February 1, 2022

Assessment Ride Report - Central Valley Greenway

Renfrew Skytrain Station

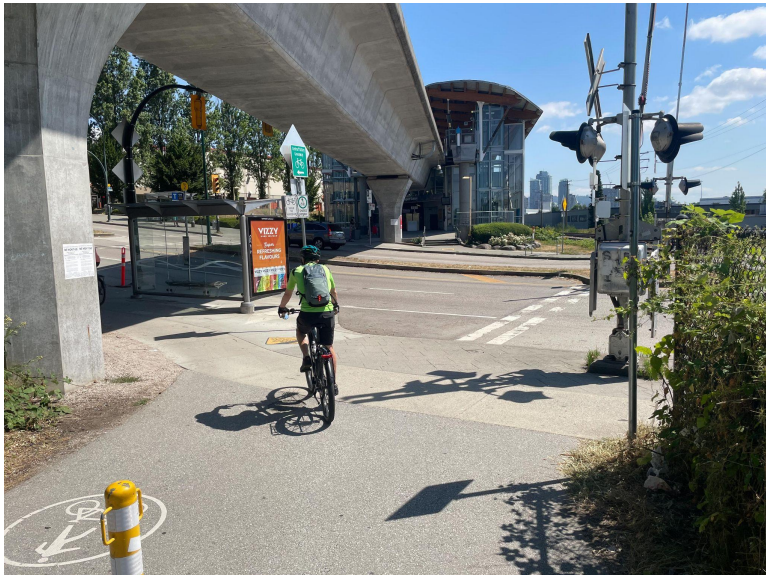
There should be larger and clearer signage to indicate how people walking and people cycling should share this space. Any assistance, such as a green-painted path for bikes, would be helpful to separate people using different modes. People cycling are directed to ride on the sidewalk, which can be confusing to people walking. The bollard in the sidewalk on 12th Ave at the station should be removed..
